MASTER DEVELOPMENT PLAN
for
WESTON OAKS

CITY OF SAN ANTONIO
Development Services Department
Interdepartmental Correspondence Sheet

The DSD – Traffic Impact Analysis & Streets Division has reviewed the MDP plan (revision dated 11-3-05) and the Level-3 Traffic Impact Analysis (TIA) for the Weston Oaks, MDP. The analysis indicates compliance with TIA Ordinance 91700 and the UDC.

COLLECTOR SECTION AT TALLEY AND EUCALYPTUS

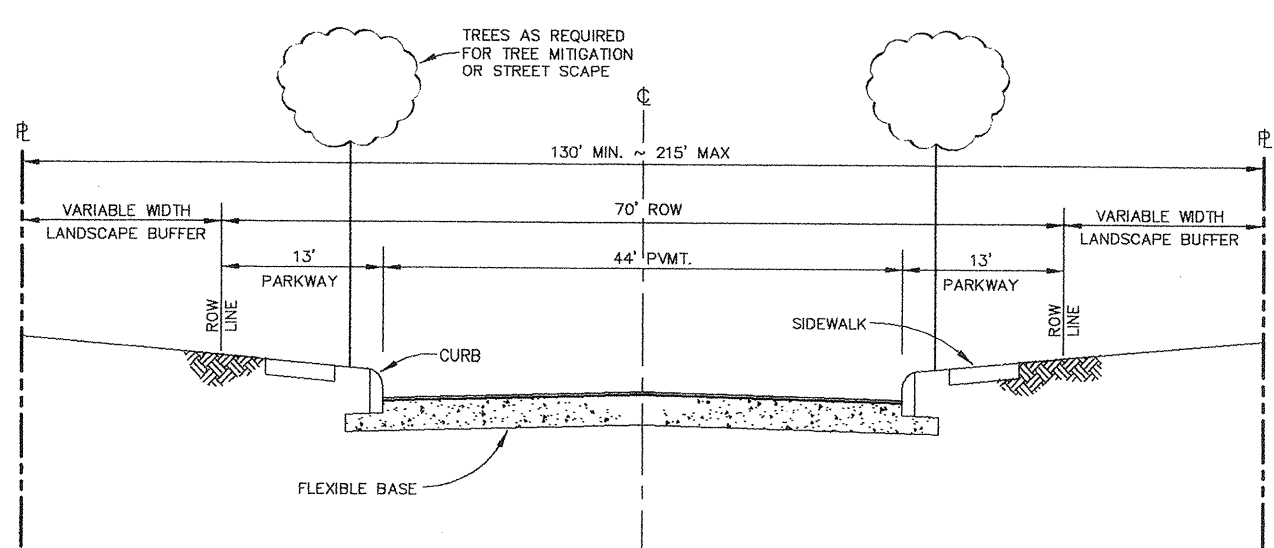
Comments: ① SHOW ROADWAY SECTION FOR COLLECTORS LINED UP
WITH TALLESPOTRANCO AND EUCALYPTUS - GROSS SPACING
② THE TIA REPORT DOES NOT INCLUDE COMMERCIAL &
SCHOOL & SIZE
③ ROADWAYS NEXT TO SCHOOLS & PARKS SHALL BE
AT LEAST 60' ± W
④ TREE SPACE ALONG LOW VISION ROADS SHALL MAINTAIN
MINIMUM 12" CLEAR ZONE

1. Show roadway section for collector lined up with Talley and Potranco and Eucalyptus and Grosenbacher.
2. The TIA report does not include commercial and school site.
3. Roadways next to schools and parks shall be at least a Local B.
4. Treescapes along low speed roads shall maintain minimum 18" clear zone.

MASTER DEVELOPMENT PLAN
for
WESTON OAKS

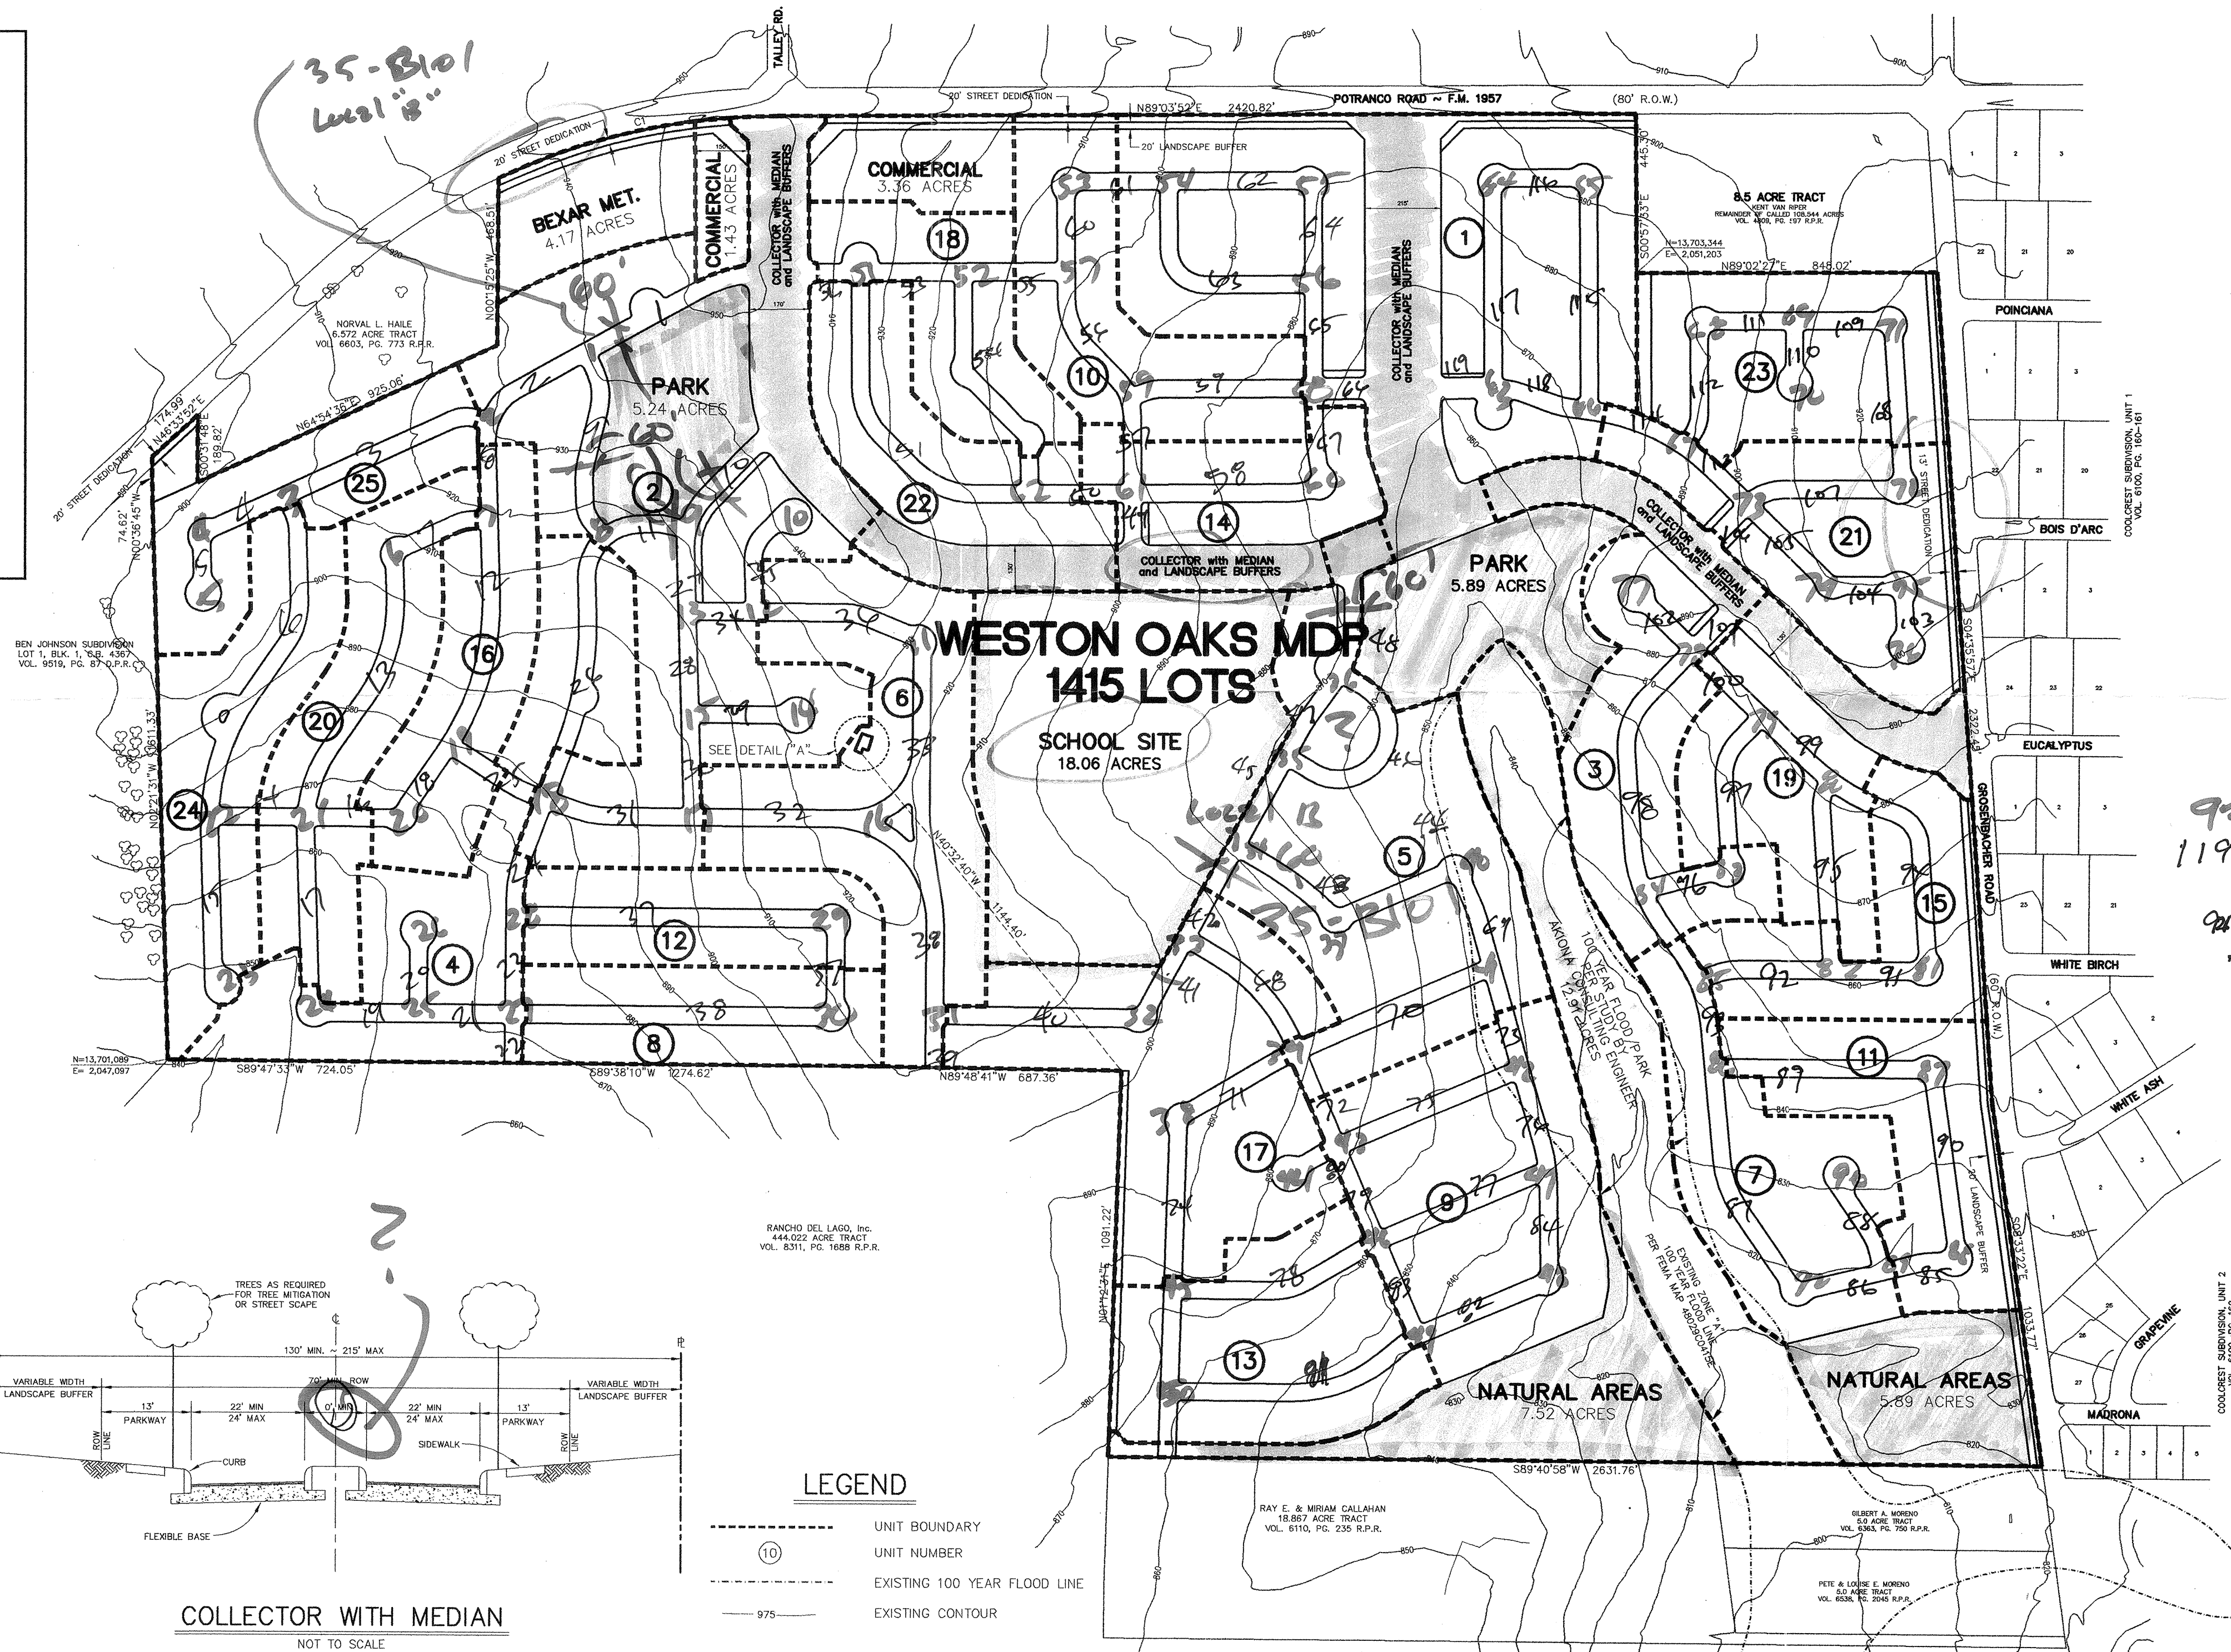
Comments: UNITS ARE NOT IDENTIFIED ON MDP REVISED 4-9-05
2) THE SUBDIVISION LOCATED WEST OF GROSEN BACHER &
SOUTH OF THE PROPOSED COLLECTION EXCEEDS 125 LOTS WITH
ONLY ONE ENTRANCE.

Proposed plan does not meet UDC 35-B101 Local B streets around Parks and Schools (Requires TIA review/approval)

- Update TIA to include Elem School & 3.36 Commercial Tract with site plan & proposed driveways.
- Show Units (Boundaries) on MDP.
- Right turn lane on NB Grosenbacher @ Potranco.
- Right turn lane on into Street A, B, C.
- Left turn lane on Potranco @ Grosenbacher, Street B, C.
- Warrant for traffic signal Grosenbacher & Potranco.
- Local B on portion of Park.
- Local B to southeast unit.
